Raleigh Park Open House #2 Summary (5/23/17)

Raleigh Park Soft Surface Trail & Stream Relocation Proposal

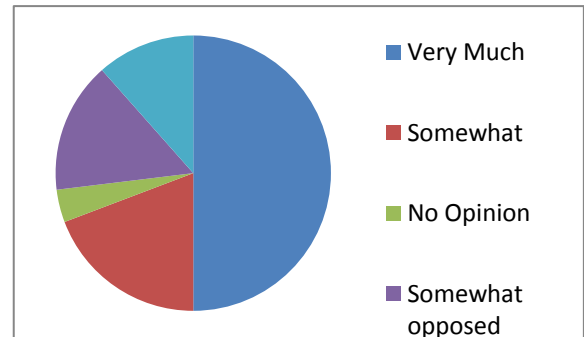
The ash grove area near SW Miner Way is a wetland area that has been seasonally mowed for recreation. Use of the area is light since it is wet for most of the year. The area currently has a horseshoe pit that is seldom used and sometimes has picnic benches. Patrons generally favor restoring this area to a natural space with improved trail access and benches.

How much do you support changing the Ash Grove into a natural area with just a trail? (Includes removing benches and horse shoe pits)				
Very Much	Somewhat	No Opinion	Somewhat opposed	Very opposed
13	5	1	4	3

- Love the look but concerned about the limitations for children to enjoy and explore the creek (N edge of picnic and south edge of ash grove) where there is constant activity during summer months. South edge of pool area doesn't seem to attract as much activity.
- If south edge of pool gets planted, we should have the alternate south trail. If no south trail (between pool and school), I would definitely contest the planting. The area behind the pool and tennis courts are primary off-trail walking areas and well-used by all.
- Kids love the creek, it would be a shame to block any part of the creek. I know the park is rented out to kids groups during the summer and those groups should be consulted.
- Worried about hard and bare riparian areas - glad to see plantings.
- The more natural the better.

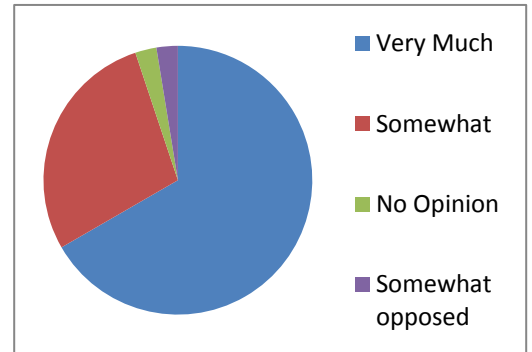
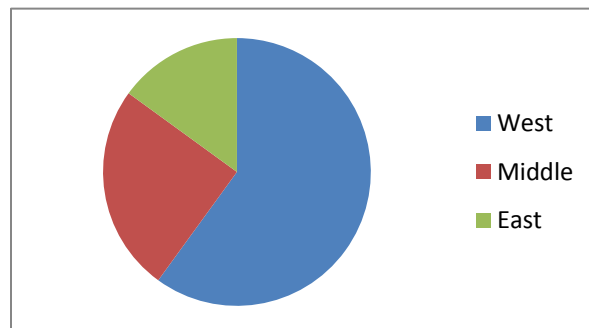
How much do you support the new park-wide trail system?				
Very Much	Somewhat	No Opinion	Somewhat opposed	Very opposed
26	11	1	1	0

Which of the three Ash Grove trails would you be most likely to use?		
West	Middle	East
12	5	3

- I would like to see a perimeter trail/path around the whole park, including North side - N middle park N of stream.
- Leave area for walking around perimeter - don't plant to the edge of the park - N middle park N of stream.
- Nature Play area - N middle park N of stream.
